# GUAM POWER AUTHORITY

## AMENDMENT NO.: III

INVITATION FOR BID NO.: RE-BID GPA-016-18

## AUDIO VISUAL (AV) RECORDING SYSTEMS EQUIPMENT

## AUDIO / VIDEO OPERATIONS DESK

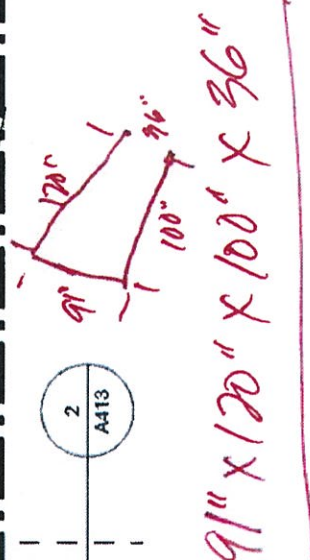
8. Please advise the location for which the Rack, Audio/Visual controller equipment and any required computer will be installed at. Also, can GPA provide a layout of the conference room showing where exactly this equipment will be installed?

Kindly see attached drawing/layout.
